# Access Compliance Report

### (Curb Ramps)

Intersection ID: 10779	Main Street: AVIDXCHANGE_LN	Cross Street: HAMILTON_ST	Location: NW
ADA ID: 1AD4E7DD9C01	Ramp Type: Perp	Initial Pass/Fail: Fail	Overall Compliance: No
Severity Score: 8.75			
Codes/Mitigation Info/Possible Solution		Field Measurements/Component Compliance

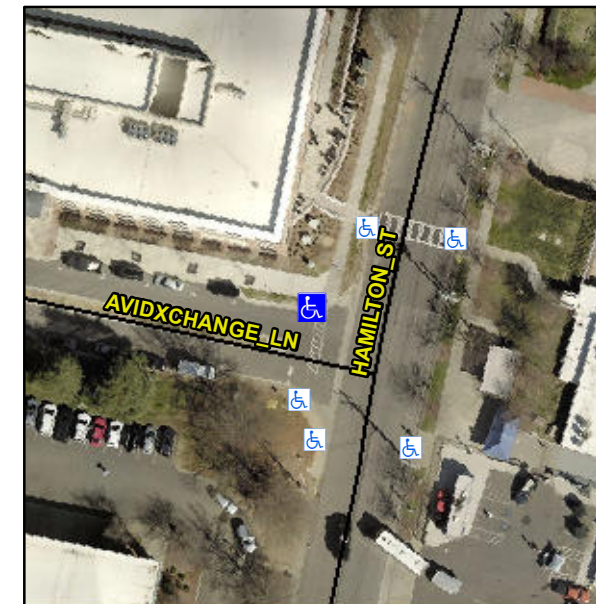
**Not Found, R304.5.1**

Compliance	Description	Data	Compliance	Description	Data
N/A	Ramp Length (in)	72.0	Yes	Ramp Slope (%)	8.0
No	Ramp Width (in)	47.5	Yes	Ramp XSlope (%)	0.7
N/A	Flare Type LT	N/A	N/A	Flare Type RT	N/A
N/A	Flare Slope LT (%)	N/A	N/A	Flare Slope RT (%)	N/A
N/A	Flare Traversable LT?	N/A	N/A	Flare Traversable RT?	N/A
N/A	Landing Length (in)	N/A	N/A	DWS Provided?	N/A
N/A	Landing Width (in)	N/A	N/A	DWS Contrast?	N/A
N/A	Landing Slope (%)	N/A	N/A	DWS Length (in)	N/A
N/A	Landing X Slope (%)	N/A	N/A	DWS Full Width?	N/A
N/A	Landing Curb? (Y/N)	N/A	N/A	DWS Offset (in)	N/A
N/A	Shared Landing?	N/A			
N/A	Gutter Ponding?	N/A	N/A	Gutter Slope (%)	N/A
N/A	Gutter Lip Ht (in)	N/A	N/A	Gutter X Slope (%)	N/A
N/A	Painted X Walk1?	Yes	N/A	Painted X Walk2?	N/A
	X Walk 1 Direction	To S		X Walk 2 Direction	N/A
N/A	X Walk 1 Width (in)	52.0	N/A	X Walk 2 Width (in)	N/A
	X Walk 1 Slope (%)	3.0		X Walk 2 Slope (%)	N/A
	X Walk 1 X Slope (%)	4.7		X Walk 2 X Slope (%)	N/A

**Remove & Replace Entire Ramp.**
